## **ALERT SERVICE BULLETIN**

**407-23-132**

**MODEL AFFECTED:** 407

**SUBJECT:** TAIL ROTOR BLADE 406-016-100-119,  
INSPECTION OF

**Figure 1 – Tail Rotor Blade 406-016-100-119  
(Cross hatched inspection area – both sides of blade)**

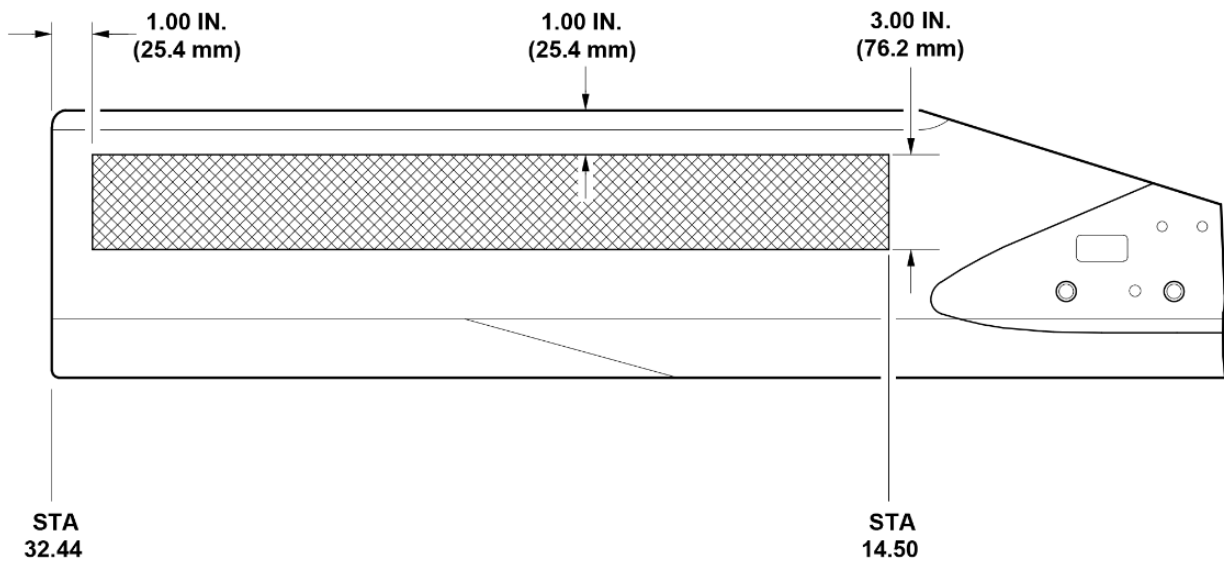
3. Inspect affected tail rotor blade for skin to core voids ([DMC-407-A-64-12-00-01A-280A-A](#) Paragraphs 3.2 and 3.3). The zone to be inspected is on both sides of the tail rotor blade as shown in the cross hatched area (Figure 1).

4. If the tail rotor blade is determined to be serviceable following the tap test, continue to step 7.
5. Tail rotor blades with skin to core voids exceeding the limits specified in Step 3 of this bulletin shall be replaced as per **PART II** of this Alert Service Bulletin.
